**Seattle
Design
Commission**

**APPROVED
MINUTES OF THE MEETING
18 December 2003**

Projects Reviewed

18 Dec 2003 Project: Center City Wayfinding – Phase II

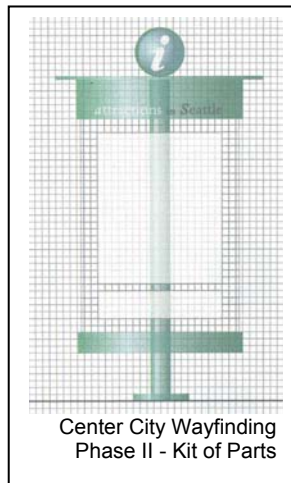
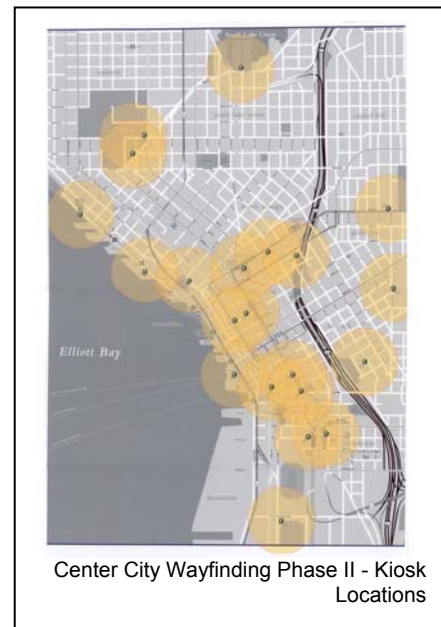
- Notes that in some places the kiosks are located very close together.
 - Proponents explained that some of the kiosks that are close together are serving different users. For example there will be a kiosk at King St Station to serve Amtrak riders, and there will also be a kiosk nearby in the bus tunnel.
- Is concerned about replace-ability. Notes that components need to be physically replaceable, but that there also needs to be an agency responsible for determining when the maps need to be updated.
- Suggests that the “i” could be bigger. Also recommends that the color could be bolder.

- Feels that stylistically the kiosks should be more contemporary. Notes that the gabled roof is a very conservative form.
- Feels that the kiosks should not be different in different neighborhoods. Thinks that it is important that they are consistent.

- Proponents explained that the kiosks need to be able to adapt to different neighborhoods and different physical conditions.
- Remarks that the “i” seems unrelated to the rest of the structure.

- Proponents explained that this is intentional so that it stands out.
- Wonders how the curved panels will work with flat printed materials.
 - Proponents stated that people having been using curved kiosks in Holland for hundreds of years. They also explained that a curved surface is ergonomically more comfortable for multiple people to look at at once.

- Questions how a commercial component to the kiosks would work.
 - Proponents explained that the commercial panel would only index the cartesian coordinates of different businesses.
